## Access Compliance Report Public Rights-of-Way (Curb Ramps)

Intersection ID: 10901 Main Street: E\_34TH\_ST Cross Street: HUDSON\_ST Location: W

ADA ID: 2B368FA5984B Ramp Type: Perp Initial Pass/Fail: Fail Overall Compliance: No Severity Score: 21.25

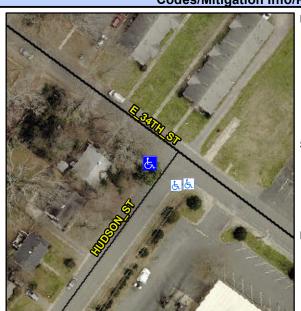
Not Found, R304.5.1, R304.5.3

Field Measurements/Component Compliance						
	Compliance Description		Data	Compliance Description		Data
	N/A	Ramp Length (in)	66.0	Yes	Ramp Slope (%)	6.4
	No	Ramp Width (in)	47.0	No	Ramp XSlope (%)	5.9
	N/A	Flare Type LT	N/A	N/A	Flare Type RT	N/A
	N/A	Flare Slope LT (%)	N/A	N/A	Flare Slope RT (%)	N/A
	N/A	Flare Traversable LT?	N/A	N/A	Flare Traversable RT?	N/A
	N/A	Landing Length (in)	N/A	N/A	DWS Provided?	N/A
	N/A	Landing Width (in)	N/A	N/A	DWS Contrast?	N/A
	N/A	Landing Slope (%)	N/A	N/A	DWS Length (in)	N/A
	N/A	Landing X Slope (%)	N/A	N/A	DWS Full Width?	N/A
	N/A	Landing Curb? (Y/N)	N/A	N/A	DWS Offset (in)	N/A
	N/A	Shared Landing?	N/A			
	N/A	Gutter Ponding?	N/A	N/A	Gutter Slope (%)	N/A
	N/A	Gutter Lip Ht (in)	N/A	N/A	Gutter X Slope (%)	N/A
	N/A	Painted X Walk1?	No	N/A	Painted X Walk2?	N/A
		X Walk 1 Direction	To SE		X Walk 2 Direction	N/A
	N/A	X Walk 1 Width (in)	N/A	N/A	X Walk 2 Width (in)	N/A
		X Walk 1 Slope (%)	1.4		X Walk 2 Slope (%)	N/A

Remove & Replace Entire Ramp.
